Reliability Analysis Update

Transmission Expansion Advisory Committee
May 8, 2026

- 2026 RTEP - Window 1
 - Schedule Update
- 2025 RTEP - Window 1
 - P5 Updates
- Scope / Cost Changes
- NJ SAA Project Cancelations

Canceled Project: Proposal 63

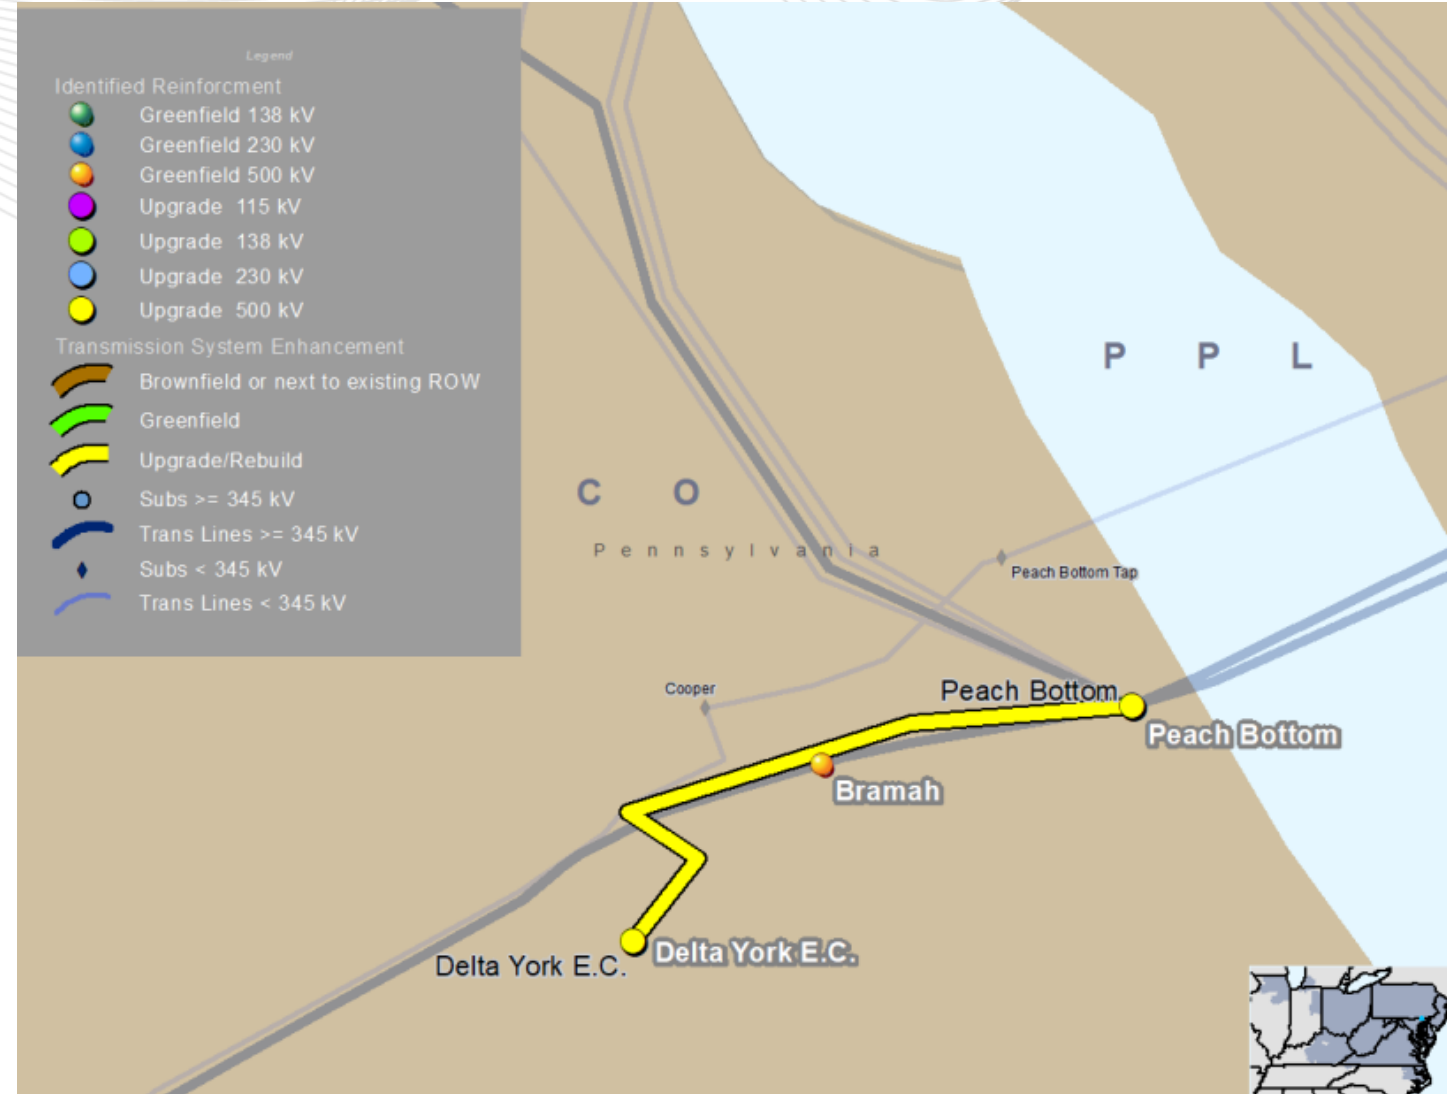
Bring the Peach Bottom-Delta York 500 '5034' kV line "in and out" of Bramah substation by partially demolishing the 5034 line to construct a new Peach Bottom – Bramah – Delta York 500 kV line, with 0.87 miles of cut-in and cut-out lines. (b3737.50)
